**Addendum No. 2**  
to  
Plans, Specifications, and Contract Documents  
for  
**T-Hangar and 2-Unit Box Hangar**  
Lumberton Regional Airport, Lumberton, North Carolina  
Addendum Date: Tuesday, February 18, 2025

This Addendum is issued by  
Talbert & Bright, Inc. 4810 Shelley Drive, Wilmington NC 28405,  
Telephone 910-763-5350 / Fax 910-762-6281

6. To the **DRAWINGS**, **REPLACE** Sheets A-121, A-601, A-602, and A-701, in Schedule 1 with the revision attached to this addendum.

- Schedule 2B Plans, Sheet CC-171:

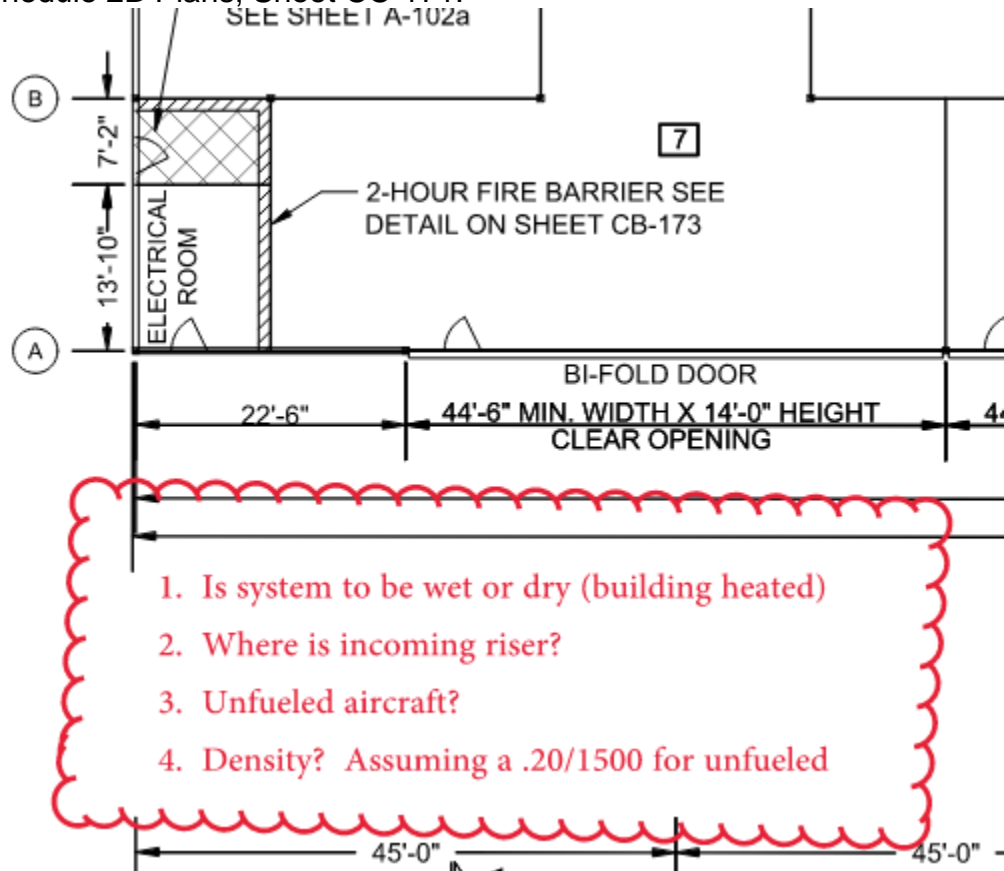
- Schedule 2B Plans, Sheet CC-171: What is this?

Answer: Those lines represent metal panel partition walls per specification Item PEB subsection 2.04 C see highlighted screenshot of your question and the highlighted items in the legend. Note that fire rated partitions are labeled and hatched.

Answer: The T-Hangars have a fire rated partition dividing the metal building into smaller fire areas, each less than 12,000 SF. Fire sprinklers are not required.

SHEET NUMBER  
**A-601**

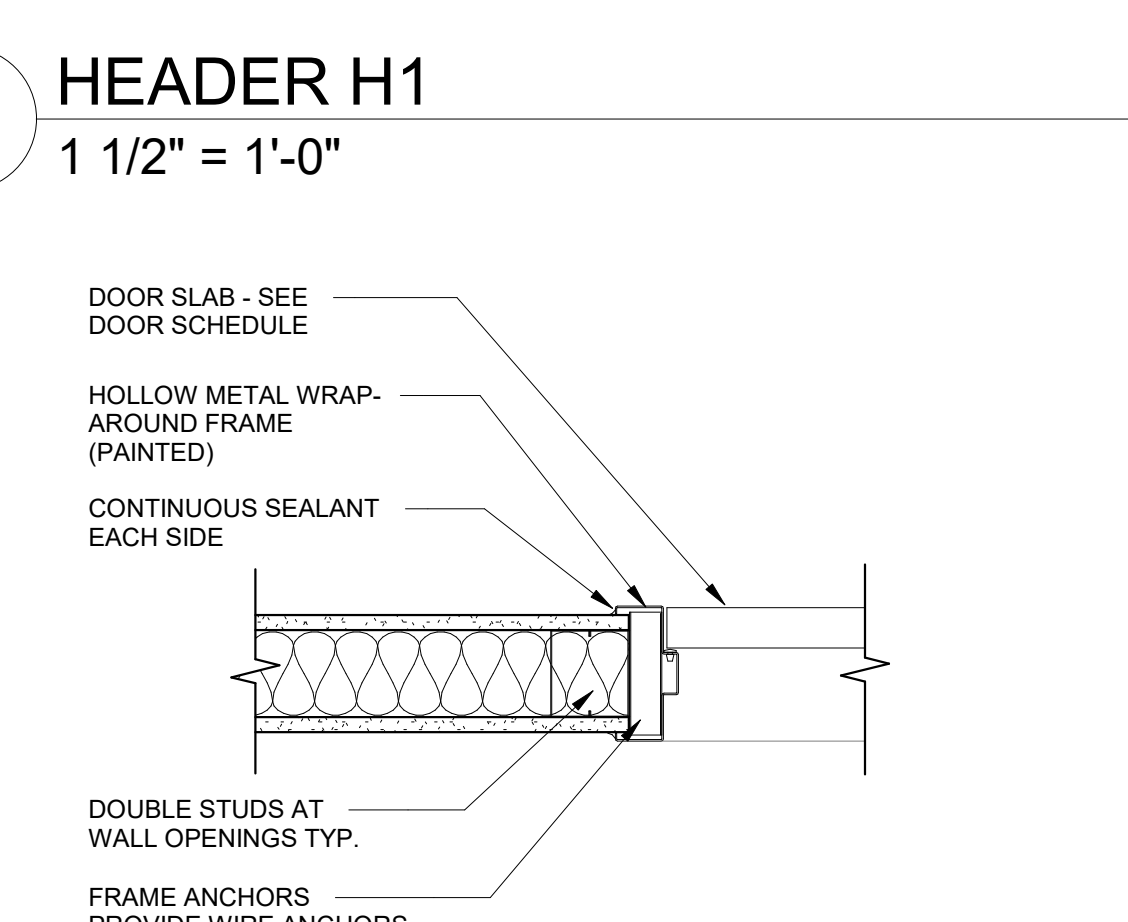
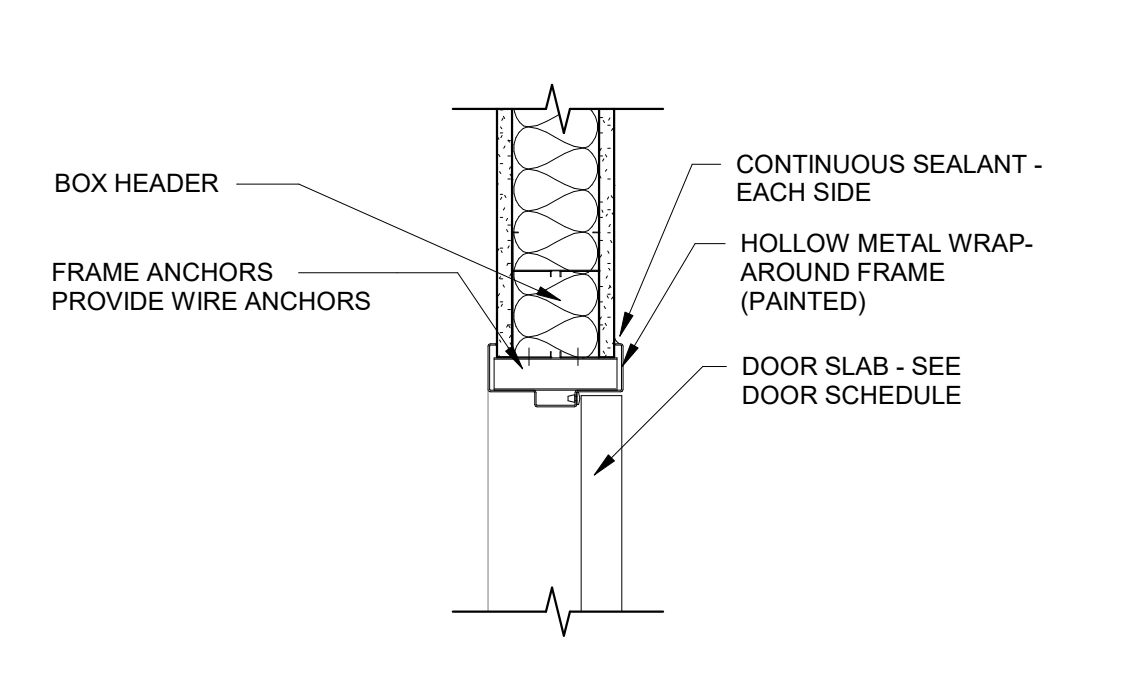
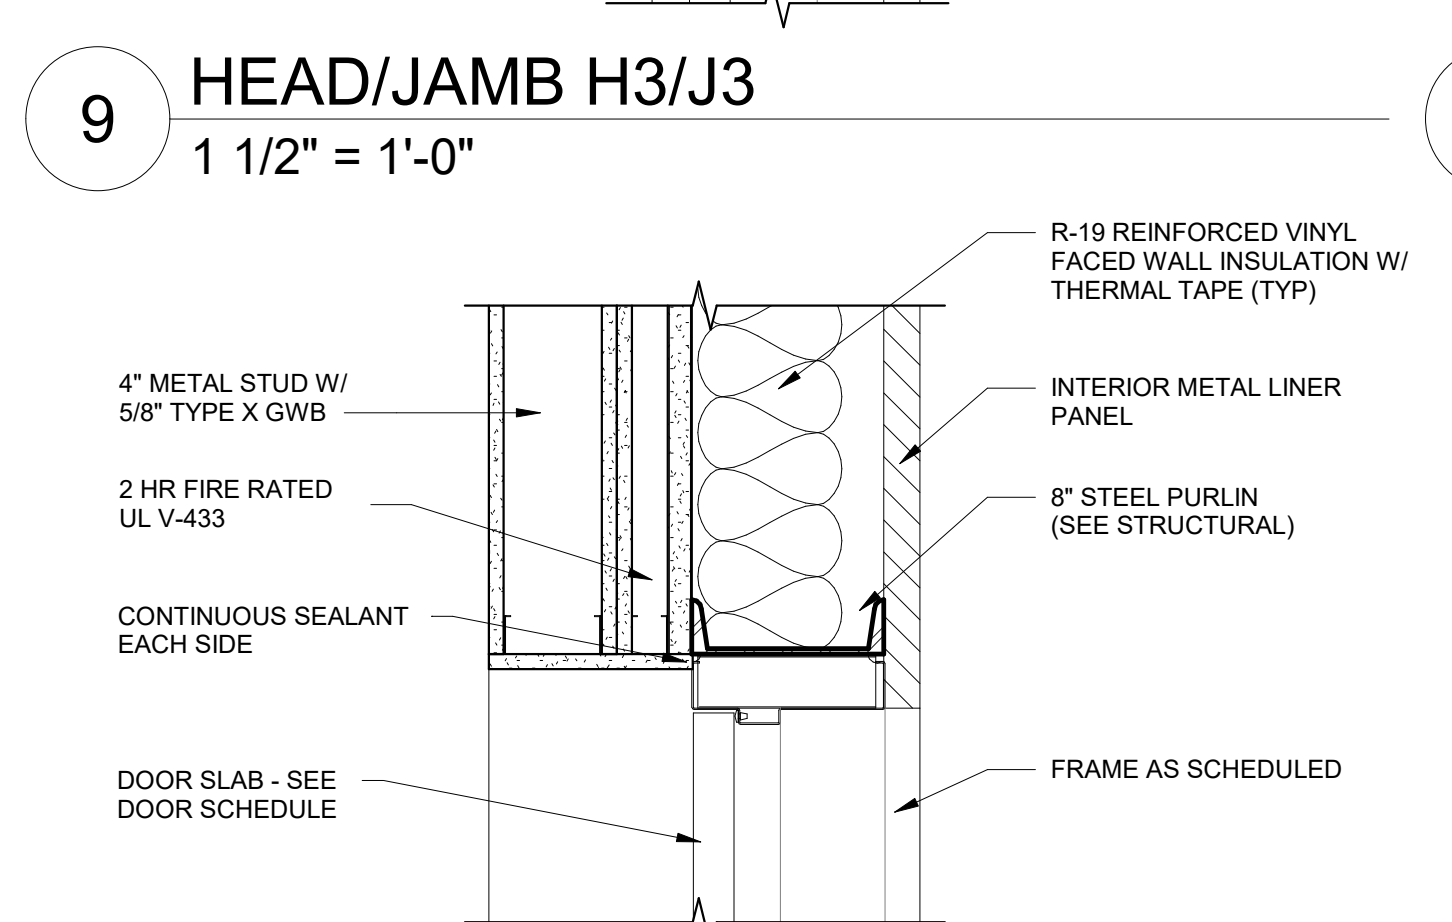
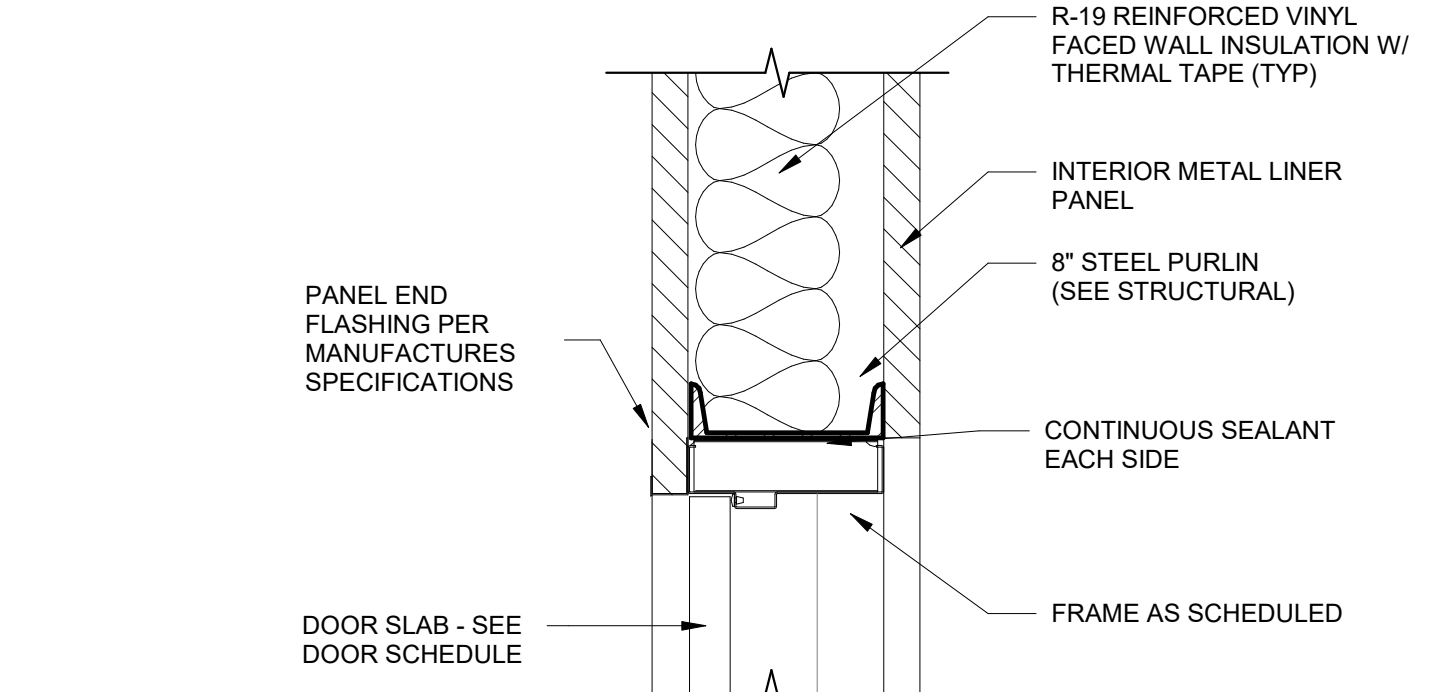
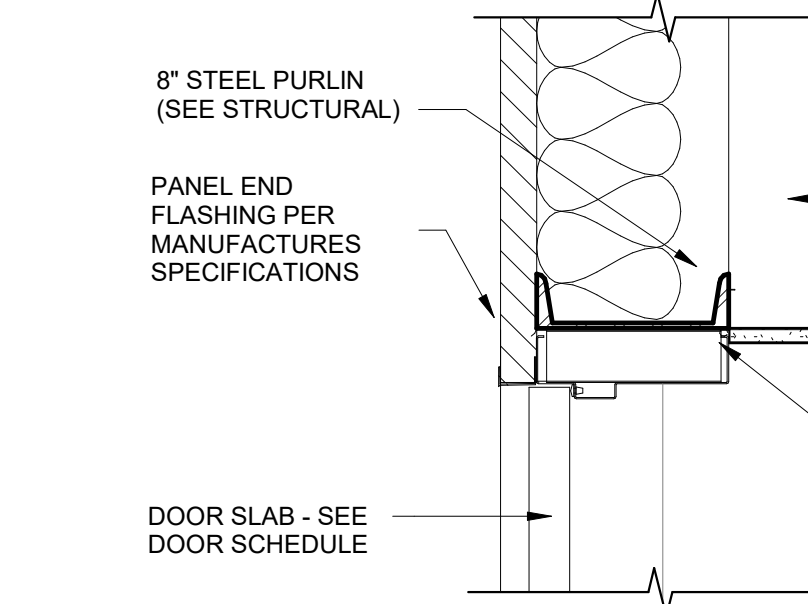
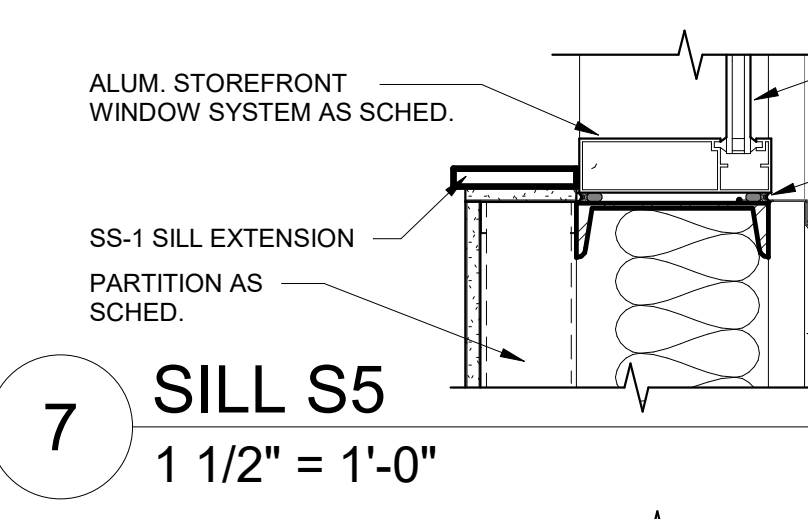
- A-602 Window Schedule Types is not complete. Please clarify. Also, A-602 Window schedule refers to header, jamb, and sill details that appear to be missing. Please provide these details.

- Appendix B, Bid Form: Building Bid Alternate Items – Item #3 “Schedule 1 - Owner’s Preferred Alternate for Hangar Door ALT-03” These doors are scheduled to be two (2) doors, each 60’X18’ doors, as shown on floor plans and elevations. However, A-601 DOOR SCHEDULE has an elevation for DOOR TYPE E Alternate #3 – indicating a single 120’ X 28’ hangar door. Please Clarify.

*Answer: See sheet A-602 for completed window schedule. Window details are on sheet A-601. See revised sheets A-601 and A-602 attached to this addendum.*

*Answer: Sheet A-601 has been revised to show 60’ clear x 18’-0” clear to match schedule. Please see revised sheet A-601 attached to this addendum.*

SHEET NUMBER  
**A-701**

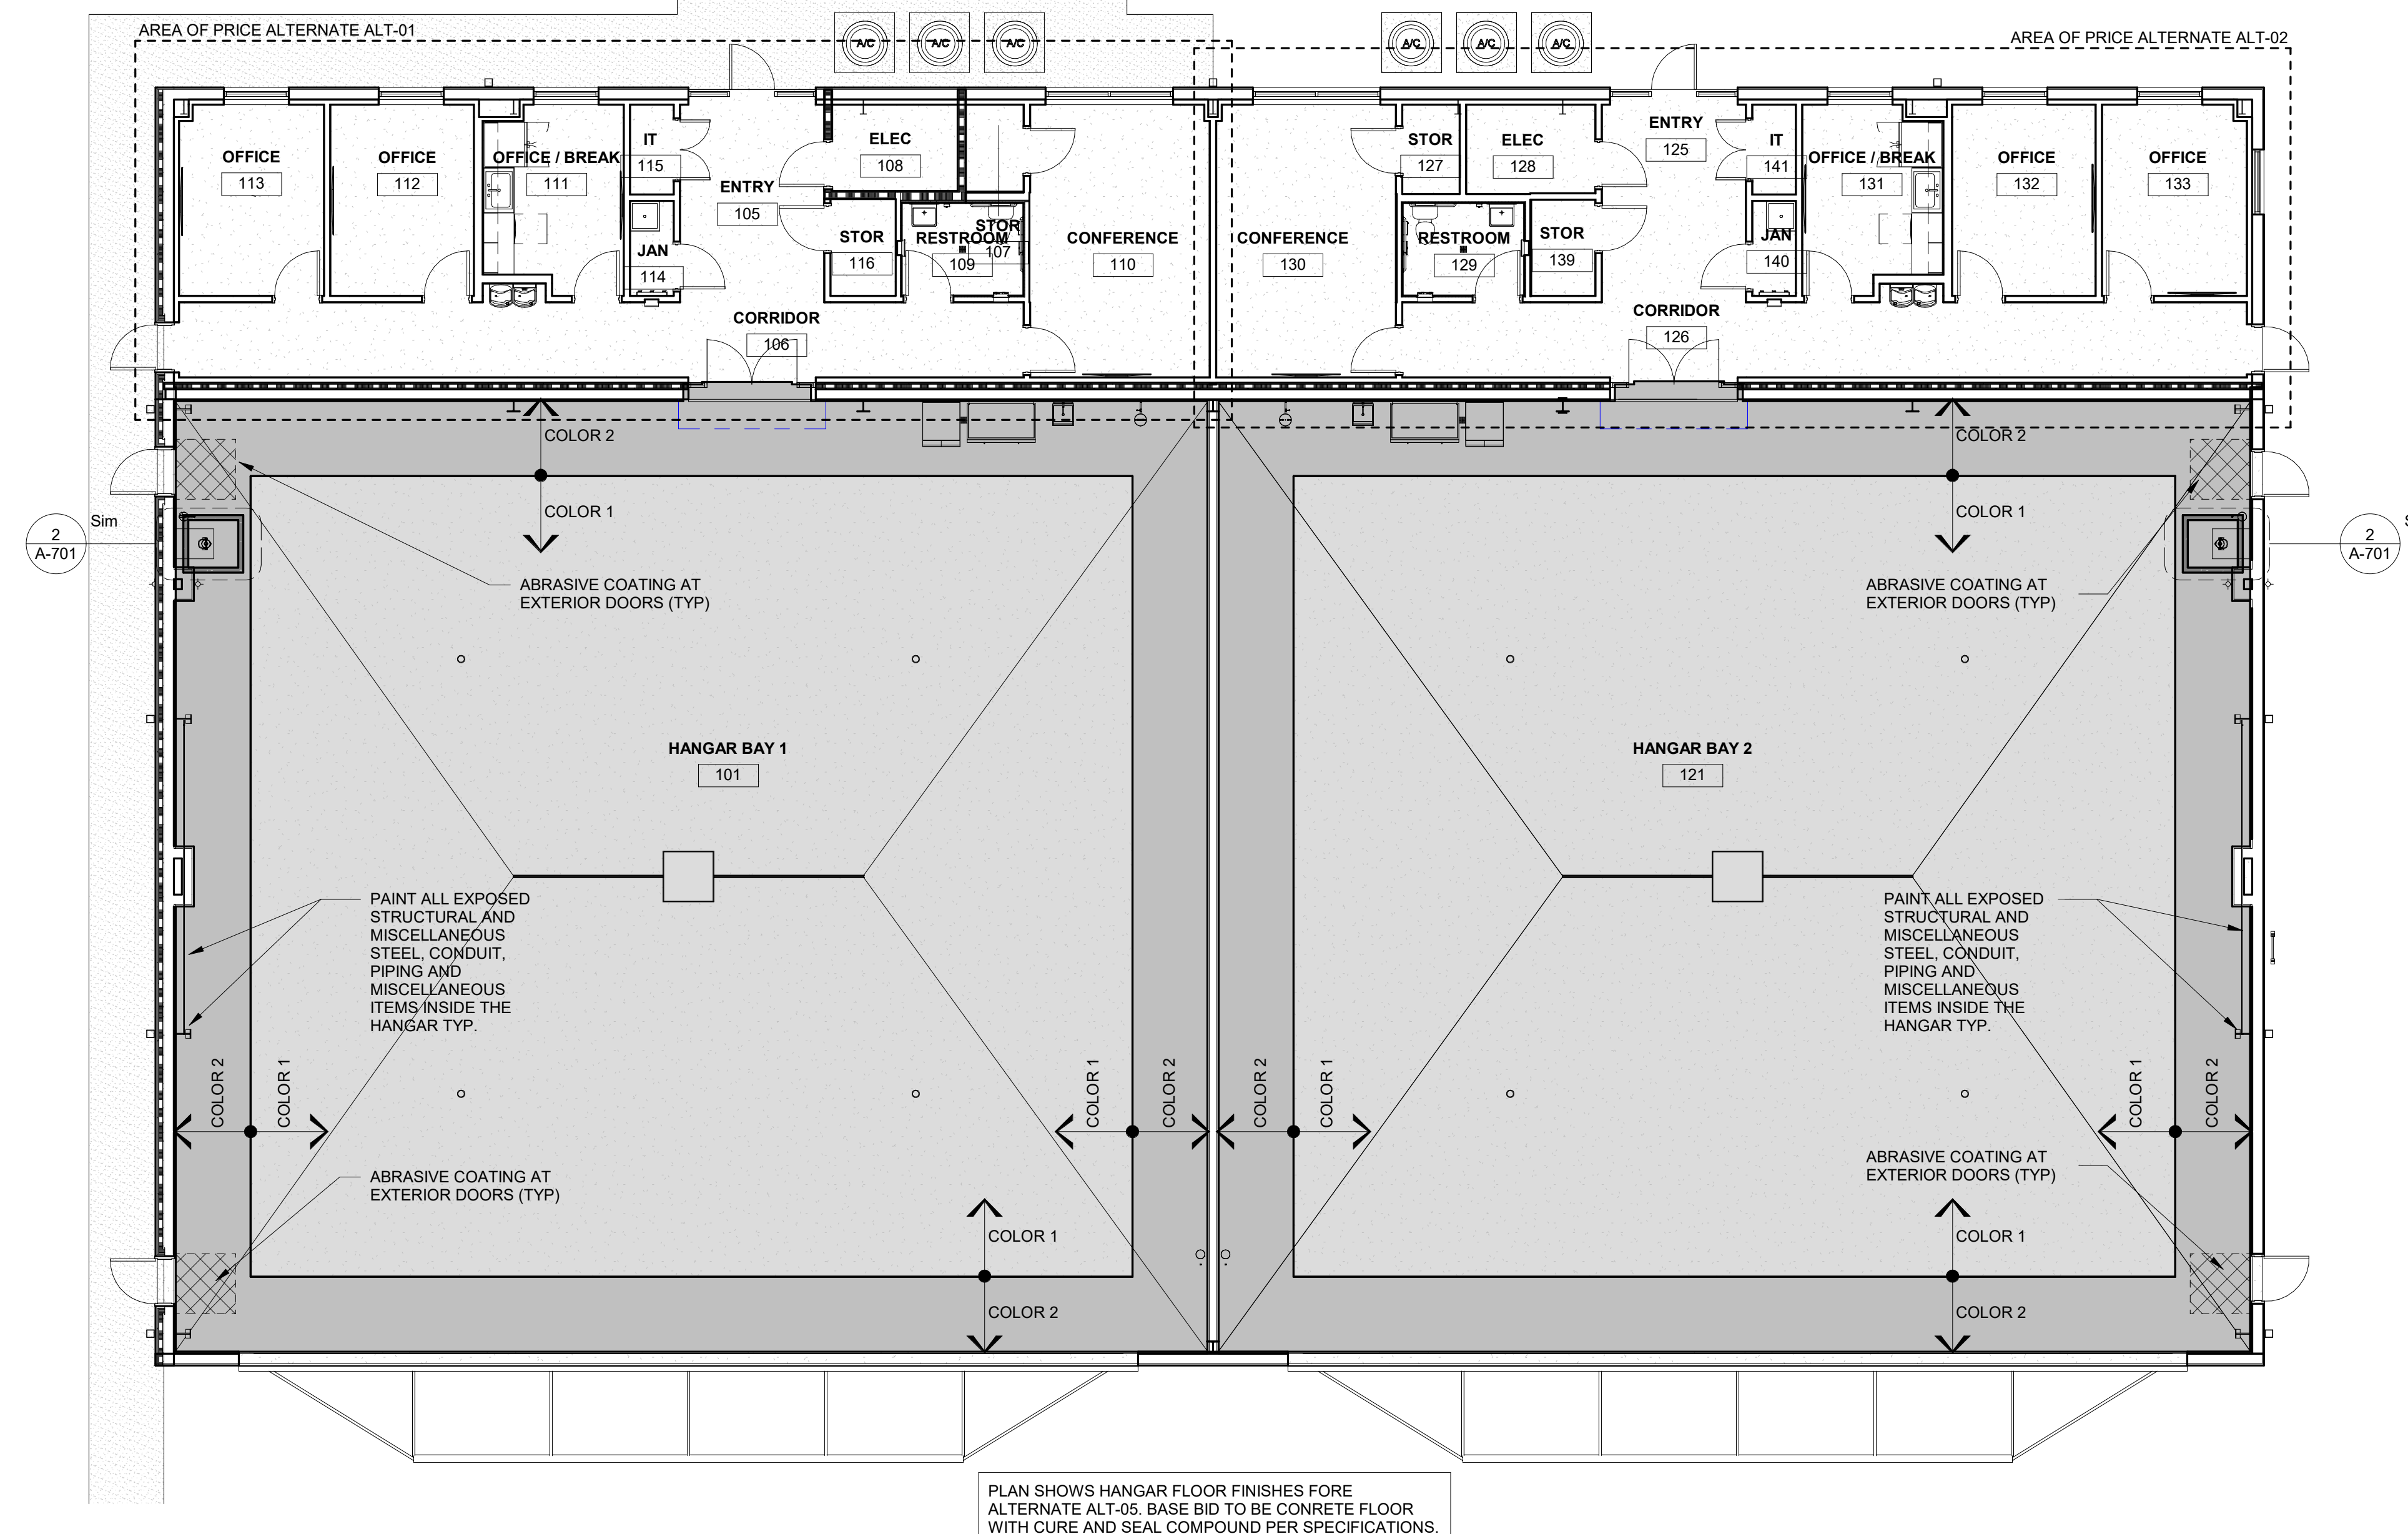
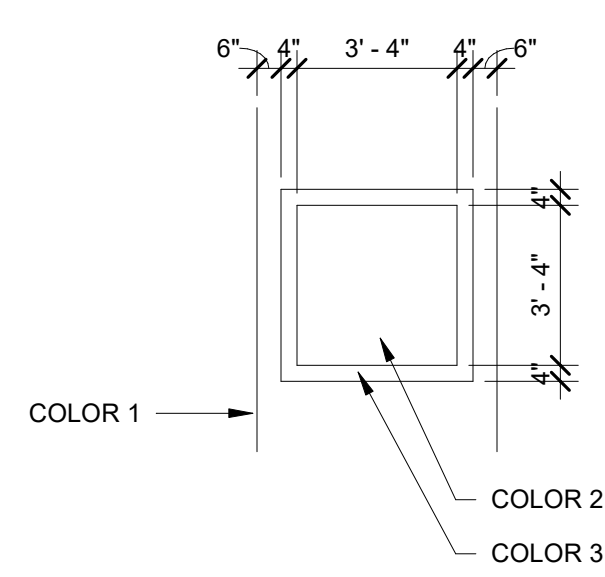
- A-701 Finish Plan and Schedules are not complete. Please clarify.

- The finishes schedule is provided on sheet A-701; however it is blank and no details regarding finishes are available on any other sheet. Please provide the required finish details.

*Answer: See revised sheet A-701 for revised finish legend and finish schedule.*

*Answer: Please see revised sheet A-701 attached to this addendum.*
